**ADDENDUM #5**

PROJECT : CODESTACK ACADEMY

REF. # : ARCH PROJ. No. 2023-04

DATE : 6 December 2024

DOOR SCHEDULE

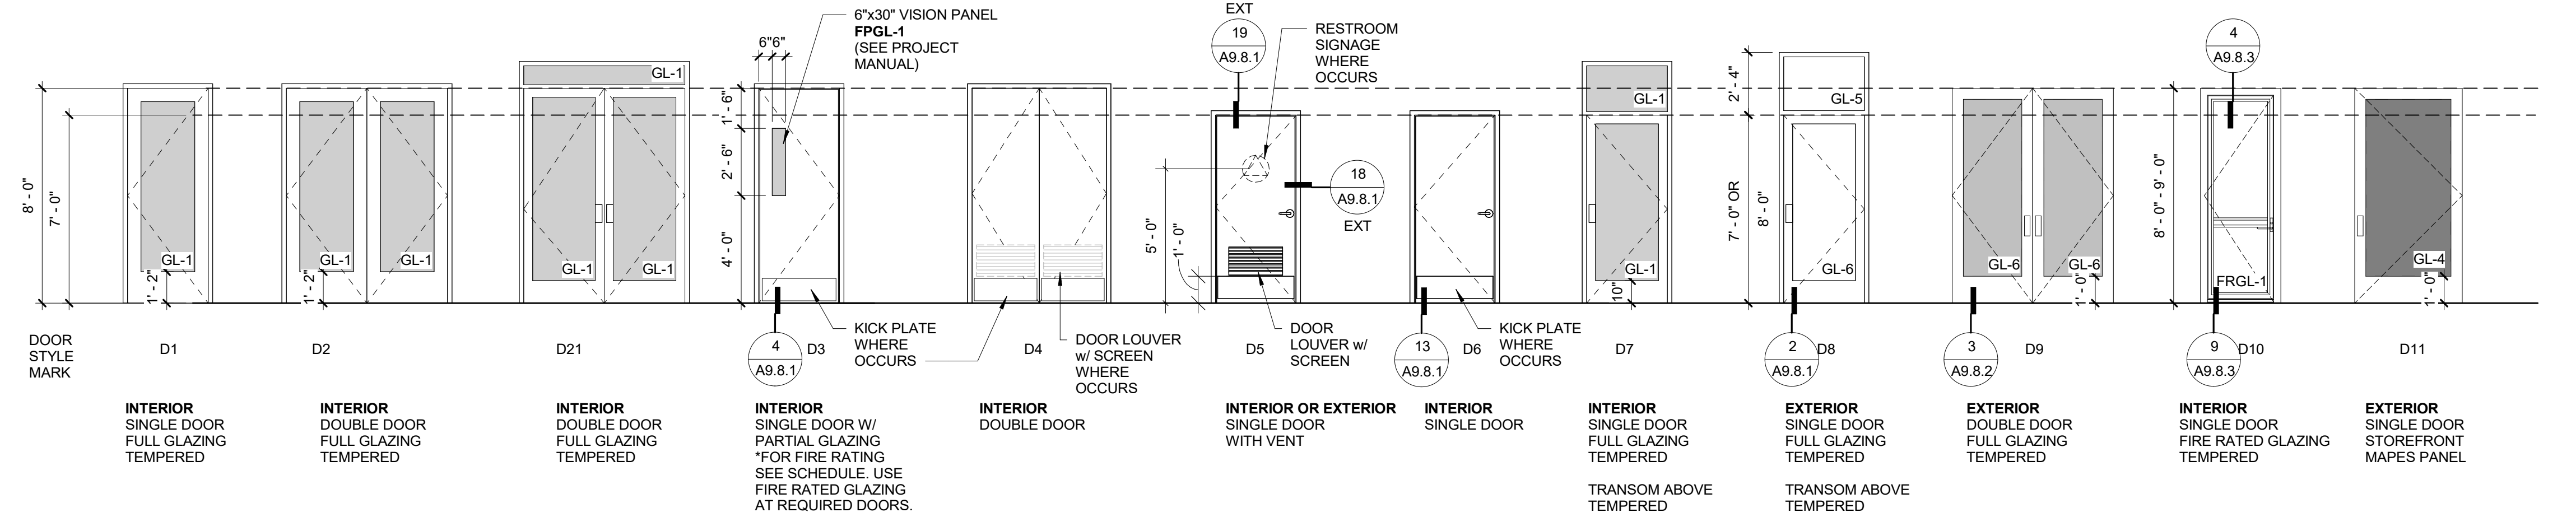
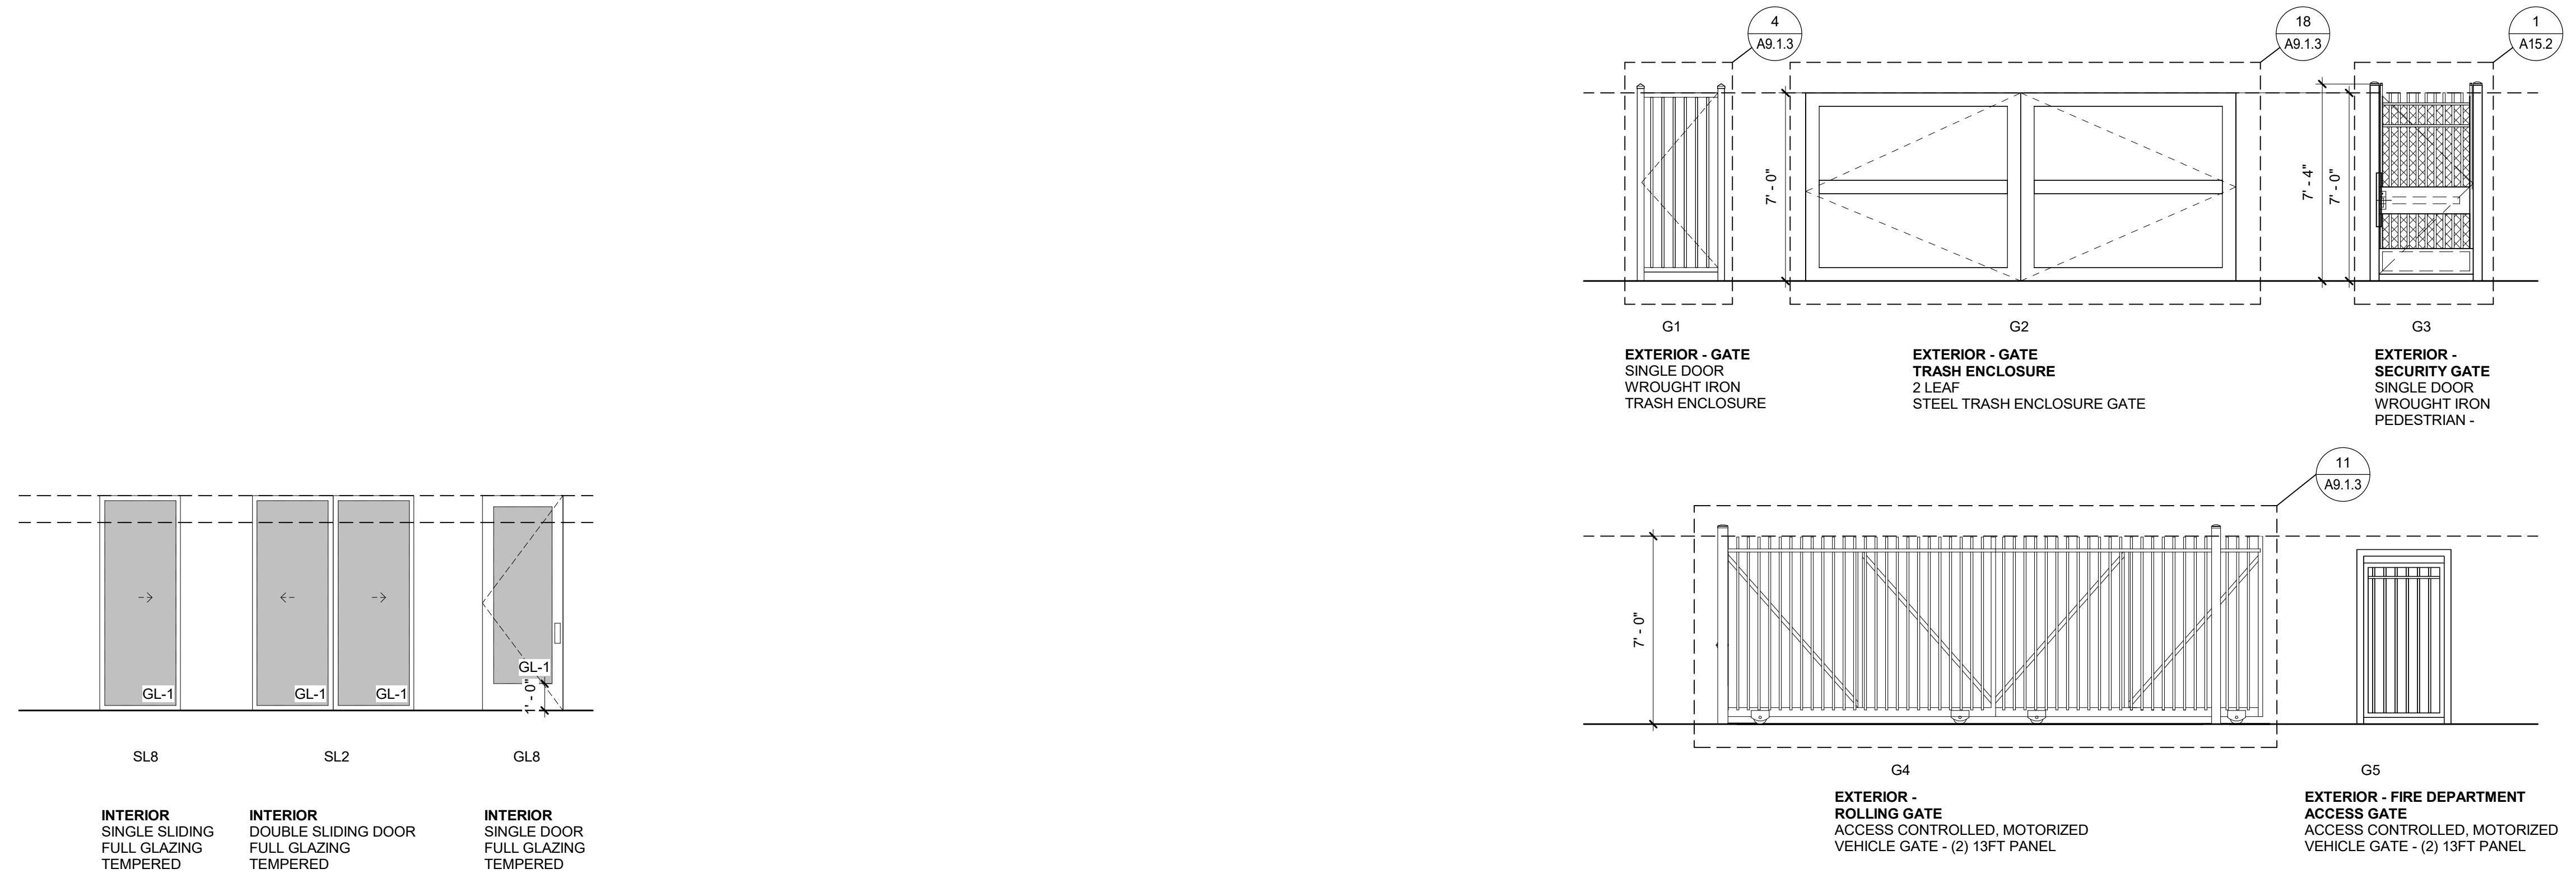
Sheets updated to include door schedule for 3<sup>rd</sup> floor that was missing.

**THIRD FLOOR DOOR SCHEDULE WAS CUT OFF IN DRAWING SHEET.  
REVISED SHEETS A8.1 & A8.2 FOR 3RD FLOOR DOOR SCHEDULE - ATTACHED.**

**BASEMENT FOUNDATION PLAN**

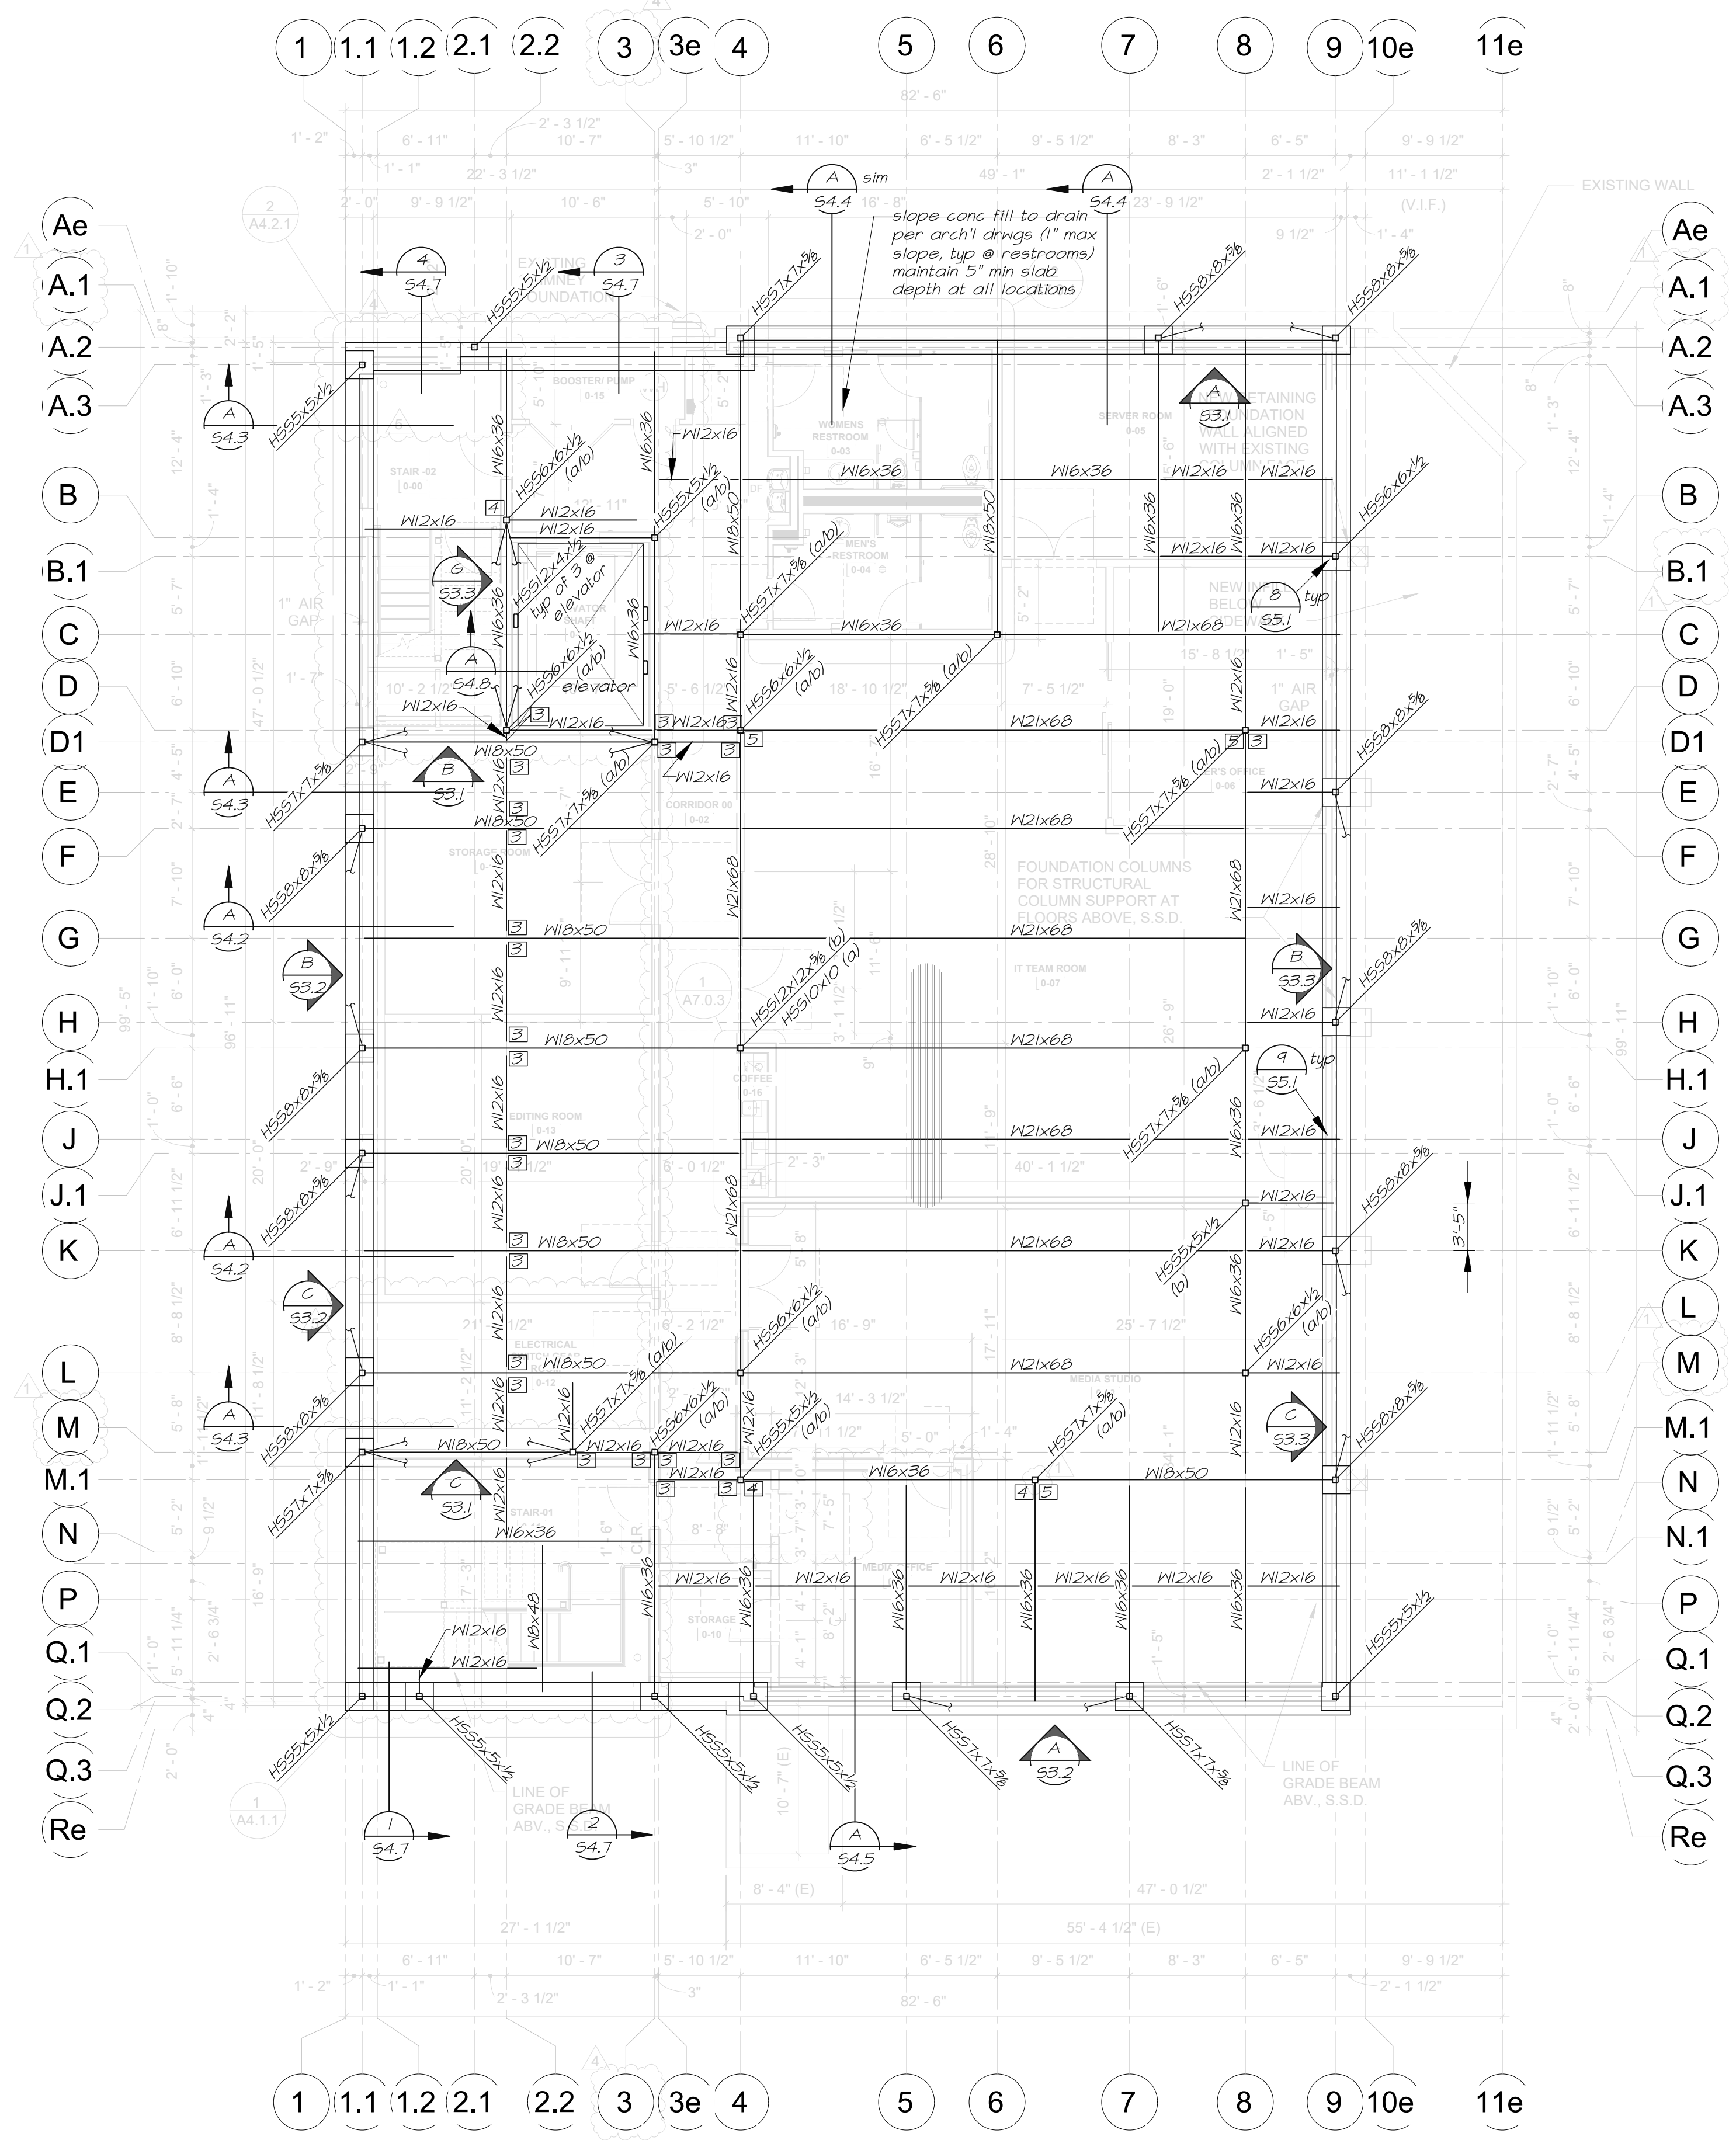
<p>REQUESTED CLARIFICATION:</p> <p>9) Gravity column bases are shown in basement S2.1 with detail 4/S5.1, however this detail does not address HSS columns over HSS 5x5x 1/2" there are 6", 7" and even 12" columns that need base plate and AB info.</p>
---

<p>RESPONSE TO CLARIFICATION:</p> <p>See the HSS column base plate schedule in 6/S5.1. Detail 4/S5.1 refers to detail 6/S5.1 for base plate information.</p> <p>by Teri Baughman - Bevier Structural Engineering, Inc 12-3-2024</p>
---

**A** Frame Line Q.3 @ Grids 5-7  
S3.2 1/4"=1'-0"

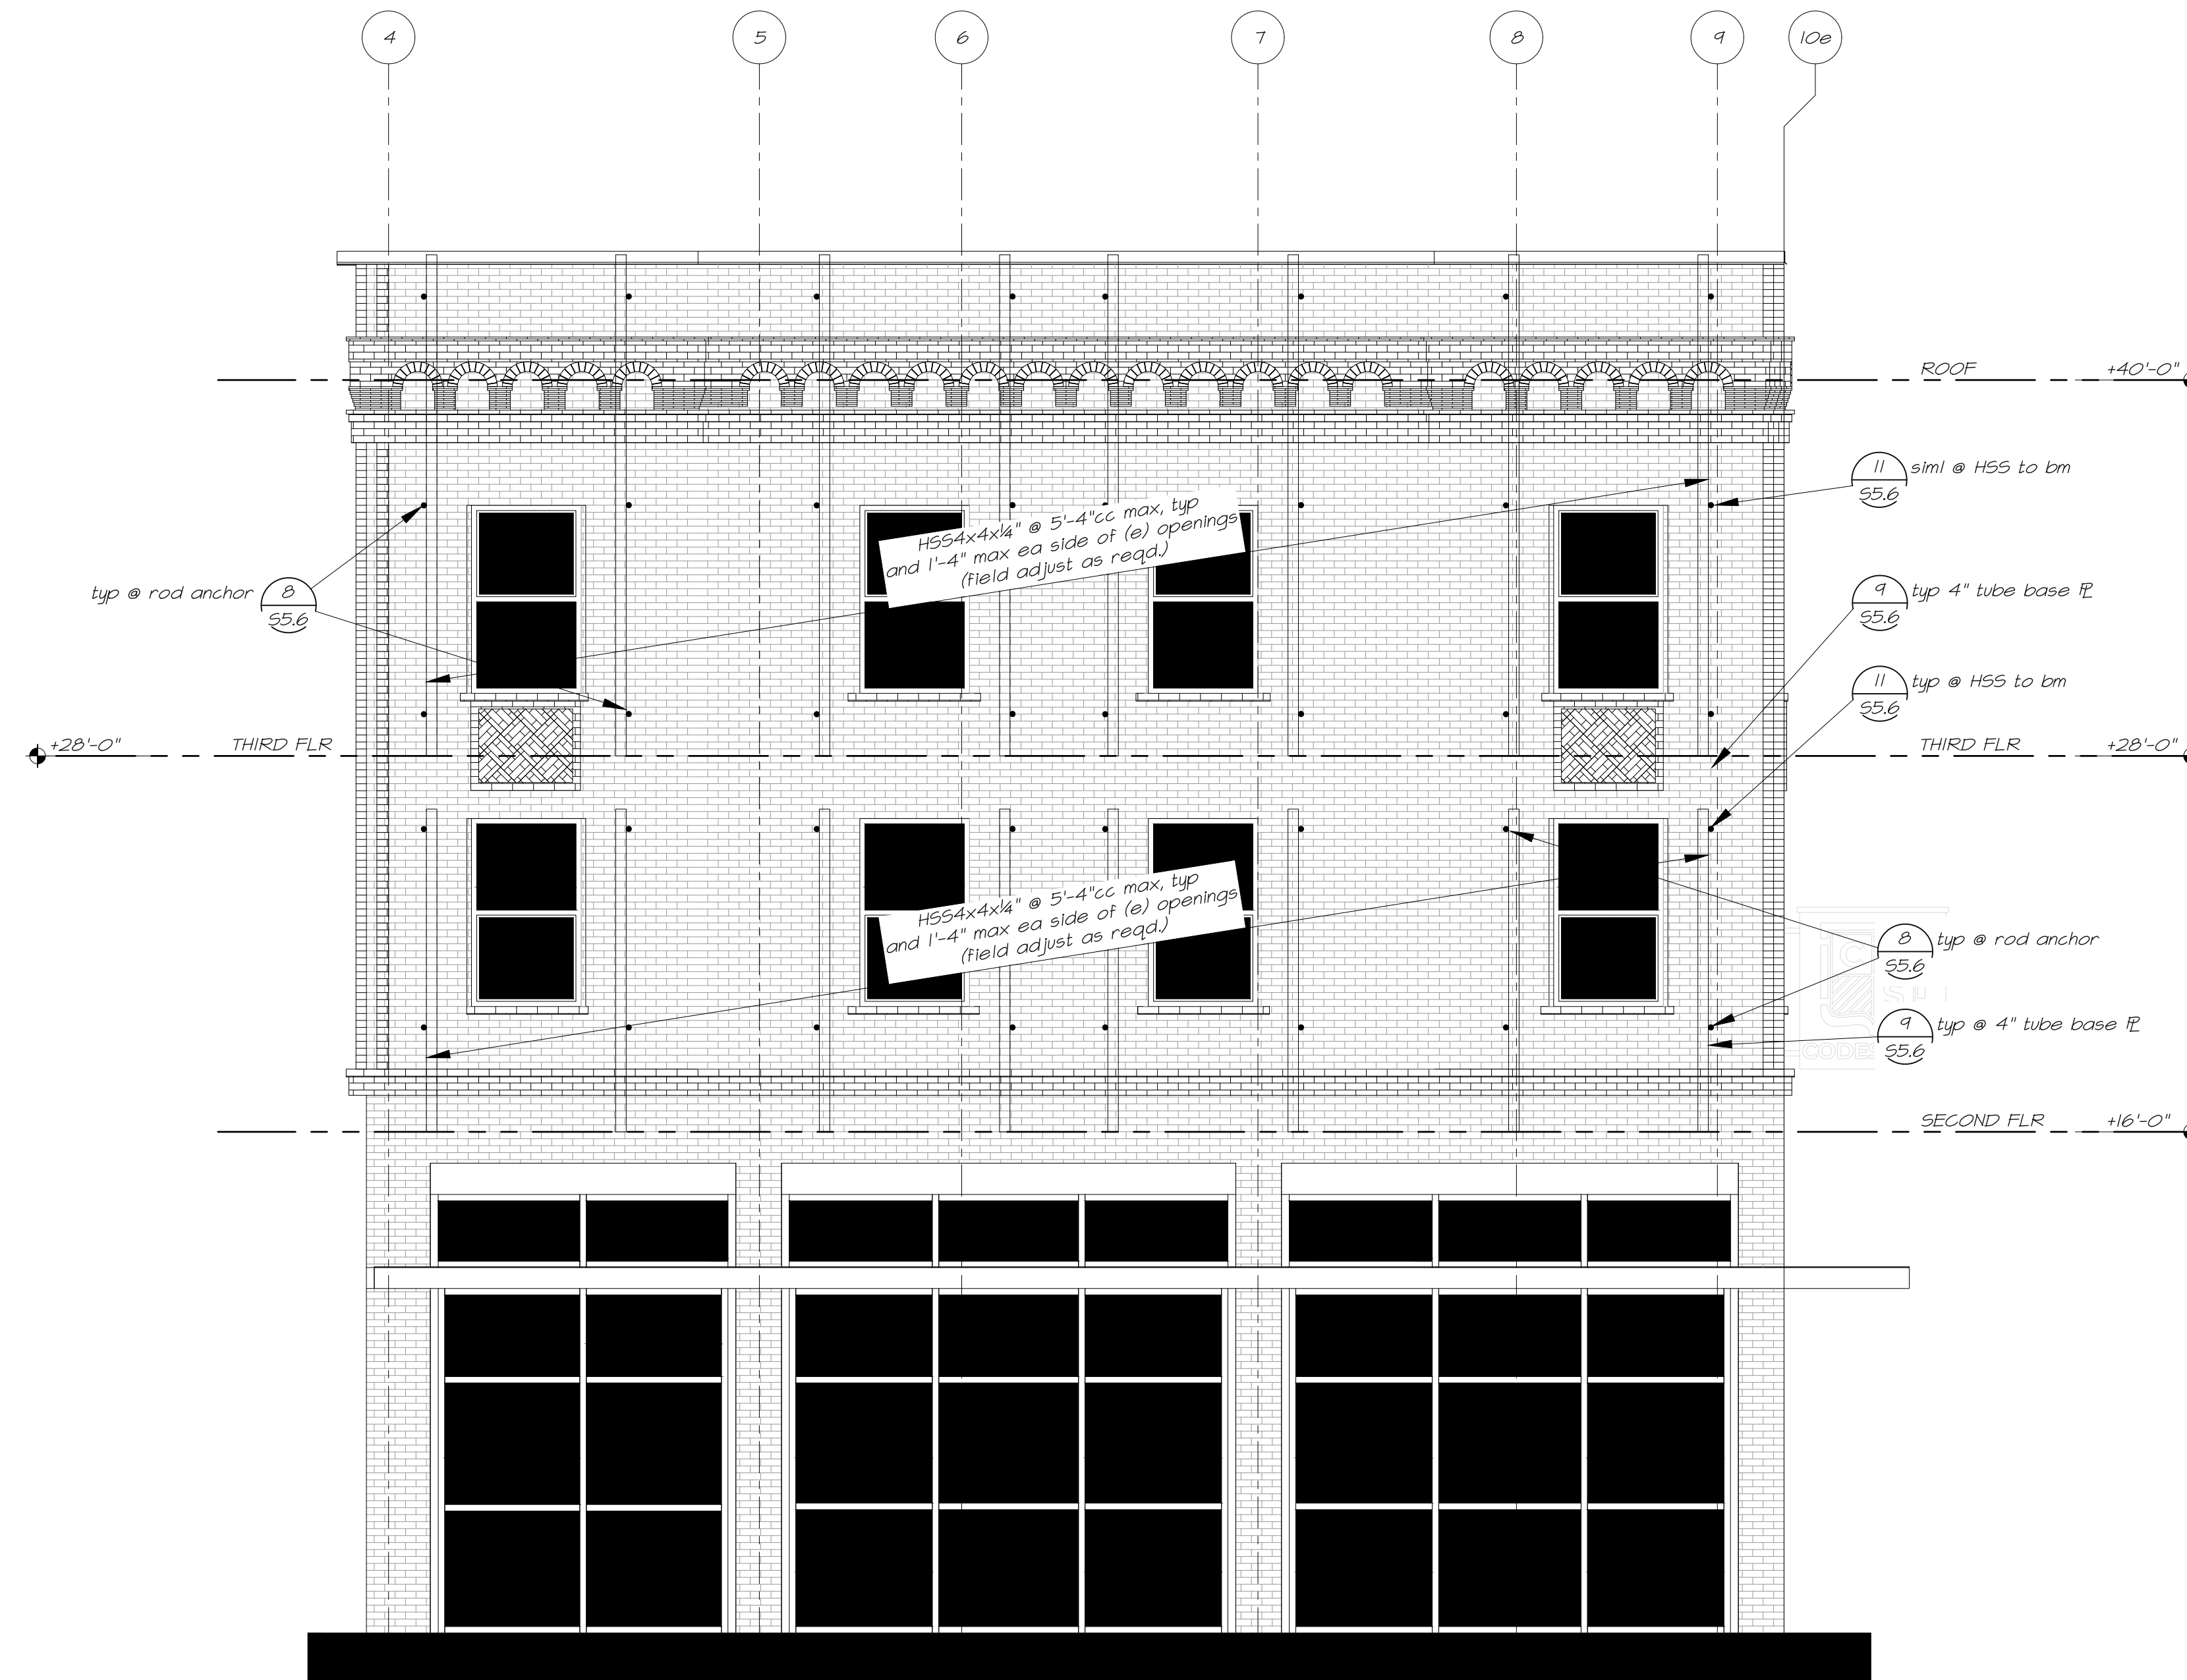
REQUESTED CLARIFICATION:
<p>4)B/S3.1 bottom of Line 1.1 shows a brace end connection to basement floor without a column base plate, please provide a connection detail for this brace to floor/wall connection.</p>

RESPONSE TO CLARIFICATION:
<p>Drawings have been updated.</p>
